Access Compliance Report Public Rights-of-Way (Curb Ramps)

Main Street: ROOSEVELT_AVE		Cross Street: EDEN_ST		Location:	SE
ADA ID: RPRK211005121737	Ramp Type:Type 1 - Perpendicular Diagonal Initial Pass/Fail: Fail		Overall Compliance: No	Severity Score:	15
Codes/Mitigation Info/Possible Solution			Field Measurements/Component Compliance

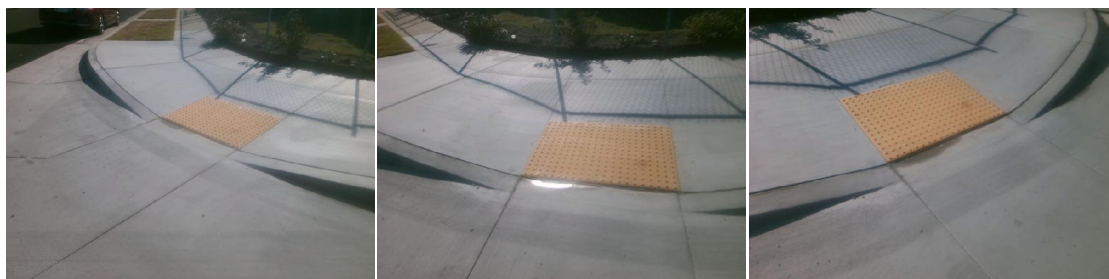
R304.2.2, STD 1115

Remove & Replace Curb Ramp With Two New Directional Ramps or Equivalent.
